| Photo | Corrective Action Required | | | | |

Photo 34

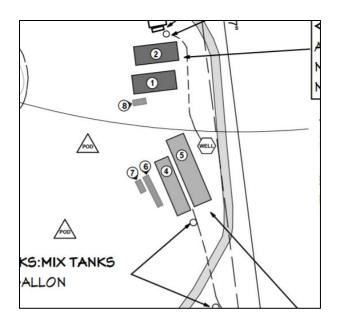
| Photo | Corrective Action Required | | | | |
|----------------------------|--|--|--|--|--|
| 34 | Area labeled as "GH 11" and "GH 10" Inaccurately labeled on site plan as being a combined area of 520 SF. Actual size of area is approximately 1600 SF. Decommission this area. Exceeds the immature plant area allotted. It is unclear how the applicant covers the lights in this area. Submit revised Site Plan showing this area decommissioned. | | | | |
